5 October 2021  
Stephen O'Donoghue  
Director Resource Assessments  
Department of Planning Industry and Environment  
12 Darcy St, Locked Bag 5022  
Parramatta NSW 2124

We refer to your letters dated 12 and 18 August 2021, requesting further information in relation to the Bulli Seam Operations (MP08\_0150) Modification 3 Application.

## Attachment A – Summary of Responses

**Figure 1: Sensitive Receivers**

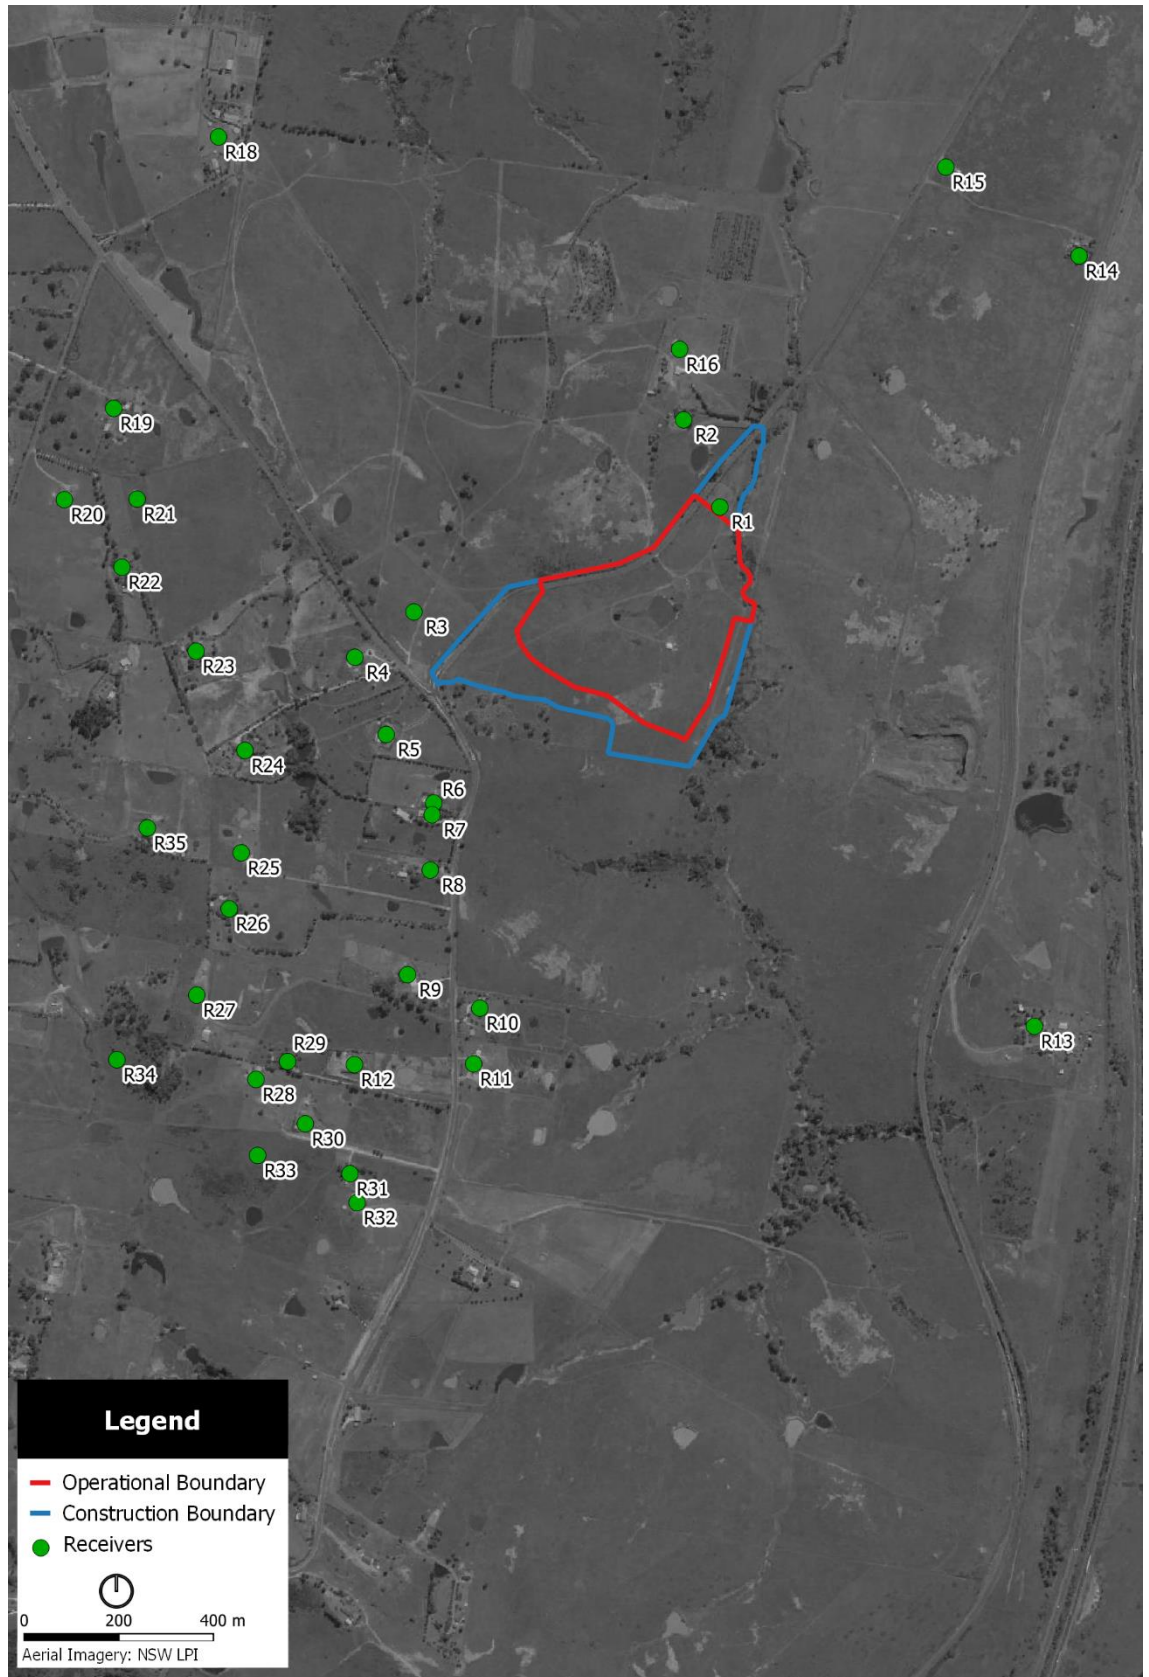
*The Department requests further analysis of predicted noise levels for the modification construction activities proposed over extended periods of time (ie. >6 months) against the project noise trigger levels (PNTLs) derived in accordance with the NPfI, including any implications under the VLAMP.*

The revised noise predictions indicate that R13 and R16 are expected to experience PNTL exceedances of up to 1dB and 2dB respectively. This corresponds to a negligible impact in accordance with the VLAMP guidelines.

Figure 2 – 30 Finns Road Photomontage locations

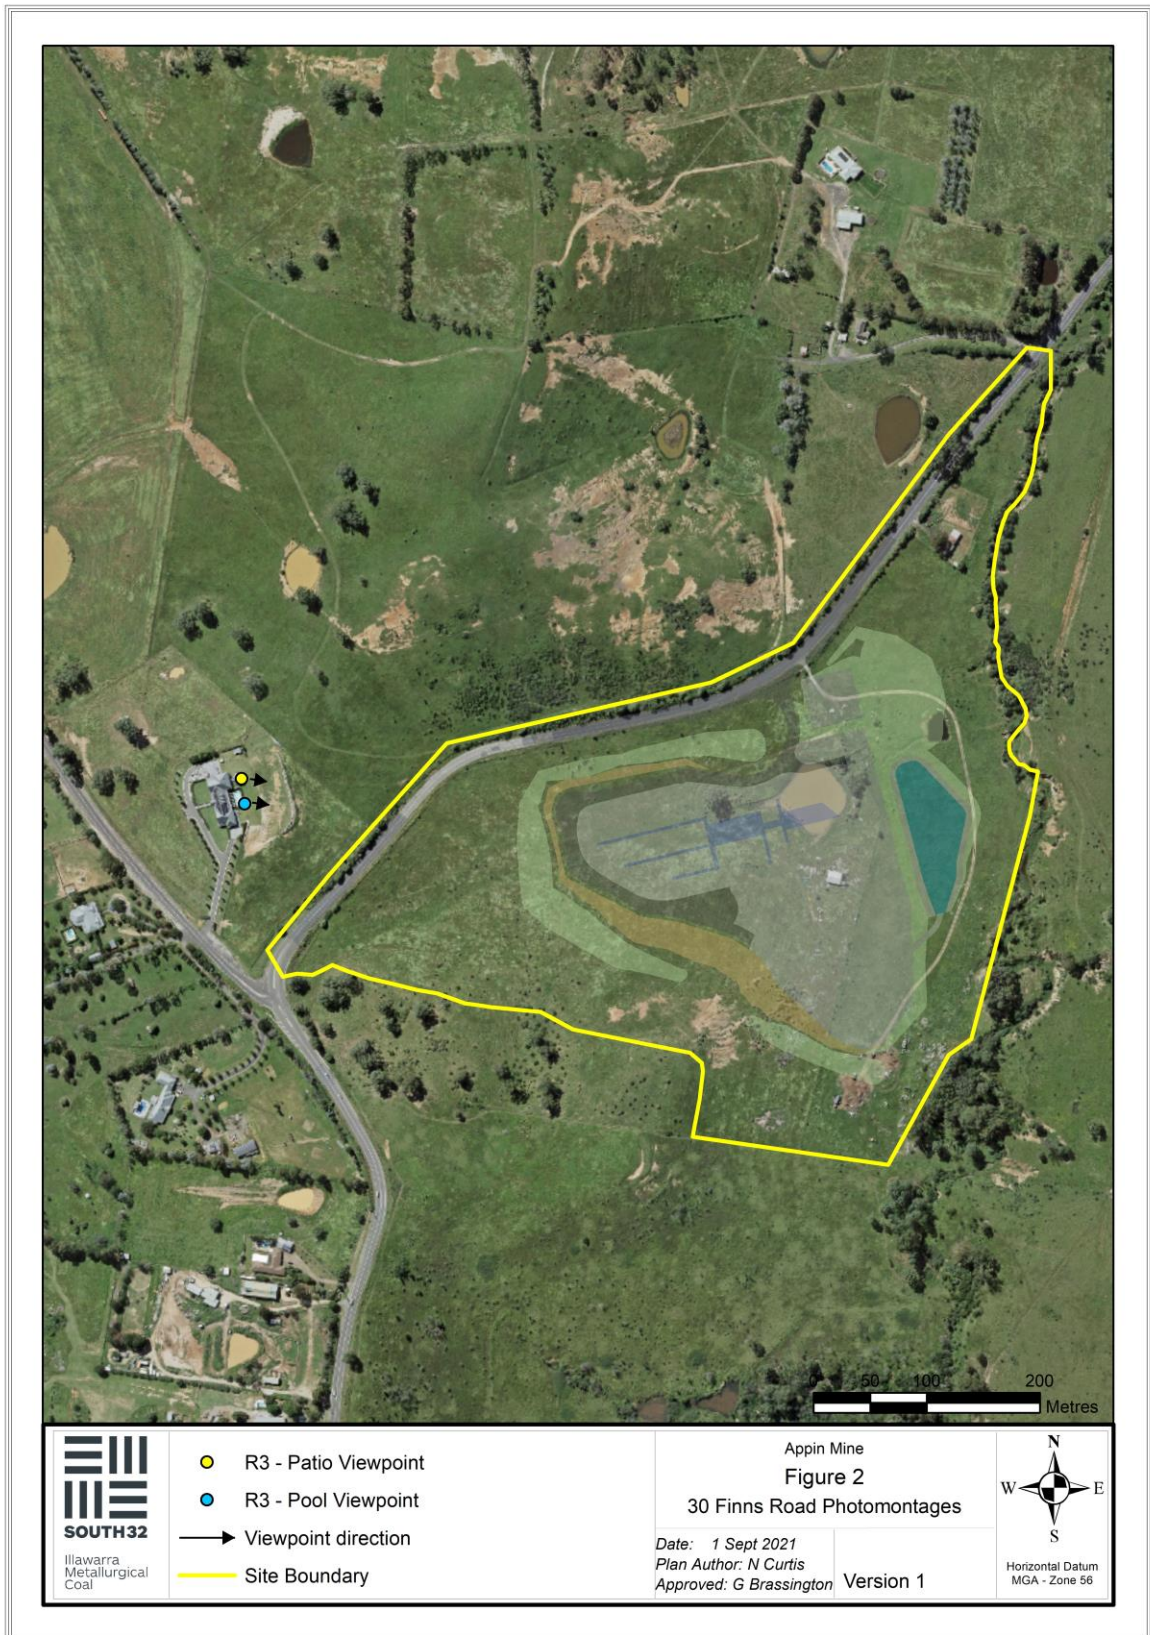
*The Department also requests an additional photomontage and more detailed discussion on how effective tree planting and screening would be to minimise visual impacts associated with the residence at 30 Finns Road (R3, VP7), noting that visual impacts to this property were raised in numerous public submissions on the modification.*

Please refer to Attachment F which includes updated photomontages from 30 Finns Road and a plan showing the locations of the viewpoints. Table 1 outlines the various phases of the Project and vegetation growth heights considered in the photomontages. The photomontages have conservatively assumed:
